SUBJECT: **700 University Avenue – Rezoning – PUD (GDP - SIP) Amended PUD (GDP-SIP) – Build 12 Story building Mix Use, 130,000 Sq. Ft. Retail, 71,000 Sq. Ft. Office, 97,000 Sq. Ft. Health Center, 62,000 Sq. Ft. Activity Center & 350 Dwelling Units – Total Building Gross Square Footage 826,000GSF**

The City Traffic Engineering Division has reviewed the subject development and has the following comments.

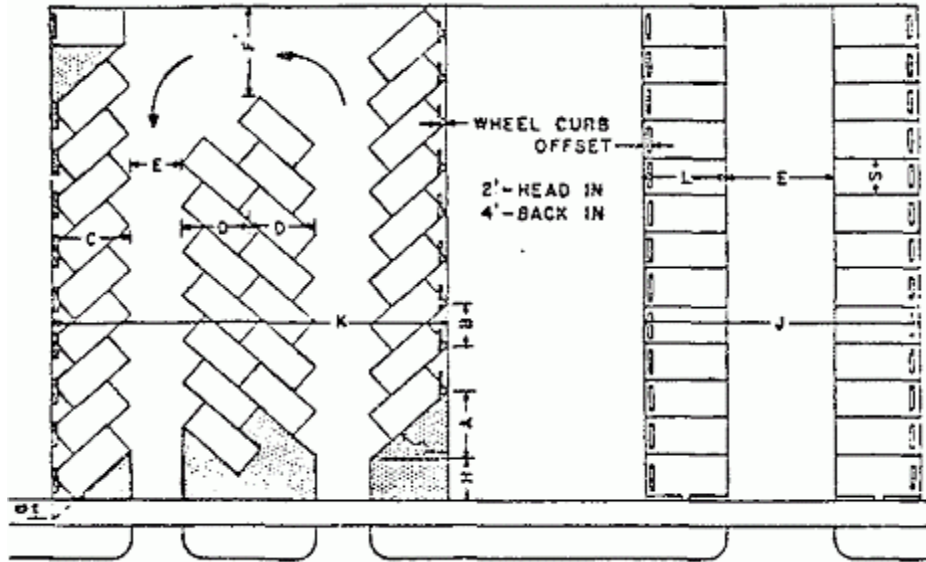
18. The applicant shall design the underground parking areas for stalls and backing up according to Figures II of the ordinance using the 9' or wider stall for the commercial/retail area. The "One Size Fits All" stall maybe used for the underground parking area only, which is a stall S = 8'-9" in width by L = 17'-0" in length with a E = 23'-0" backup. The applicant shall modify and dimensions for proposed parking stalls' items S = 17 ft., B = 8.75 ft., C = 17 ft., D = 17 ft., E = 23 ft., and F = 20 ft., and for ninety-degree angle parking width and backing up. The applicant shall modify ramp parking which no stair cases, elevators, aisles, ramps, columns, offices or work areas are to be excluded from these rectangular parking space S, B, C, D, E, & F, when designing underground parking areas.
